**Evektor SportStar Modification
Bulletin SportStar-002a Alternate Compliance**

**AvSport SI-EVSS-02
12 November 2012**

<p>OPTIONAL SERVICE INSTRUCTION</p>
--

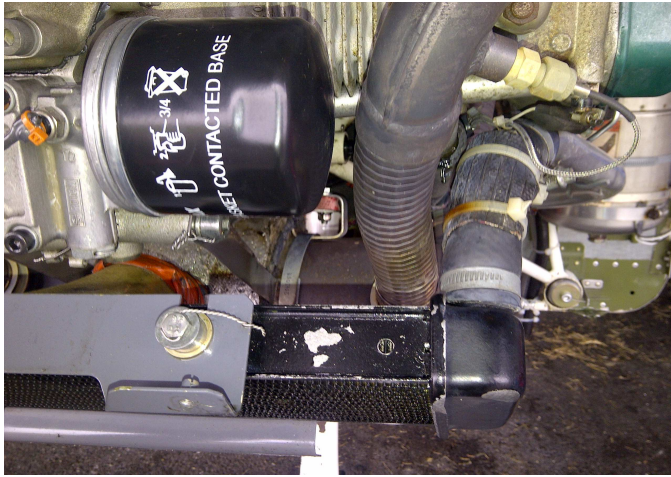
1. Remove engine cowling
2. Prepare two 10 cm lengths of firesleeve
3. Seal ends of firesleeve with end dip or RTV to prevent fraying and fluid wicking
4. Slide two firesleeve clamps onto firesleeve
5. Drain engine coolant
6. Remove left side rubber hose from radiator by loosening hose clamp
7. Slide firesleeve over rubber radiator hose
8. Reinstall hose onto radiator and secure hose clamp
9. Slide one firesleeve clamp to within 5 mm of each end of firesleeve
10. Secure firesleeve to hose by tightening both firesleeve clamps
11. *Optionally:* Repeat steps 6 through 9 on the right side rubber radiator hose
12. Refill radiator and cooling system with approved coolant
13. Reinstall engine cowling

Pre-modification clearance

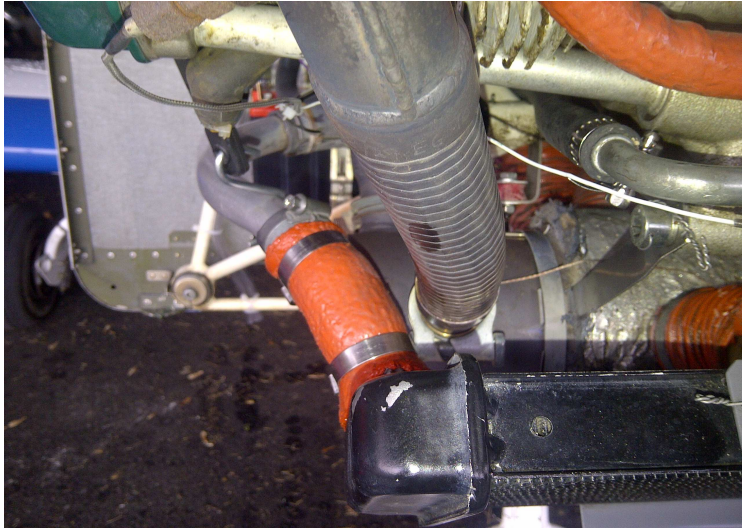
<u>Test Phase</u>	<u>Pipe to Hose</u>	<u>OAT</u>	<u>Cyl #2</u>	<u>Measured surface temperature °C</u>	
	<u>Clearance</u>	<u>°C</u>	<u>EGT °C</u>	<u>Exhaust Pipe</u>	<u>Radiator Hose</u>
Pre-modification	<u>20 mm</u>	<u>+5</u>	<u>671</u>	<u>268</u>	<u>256</u>
Post-modification	<u>08 mm</u>	<u>+5</u>	<u>655</u>	<u>248</u>	<u>161</u>

Summary: The firesleeve adequately protects the radiator hose from heat damage.
All objectives of this modification have been satisfied.
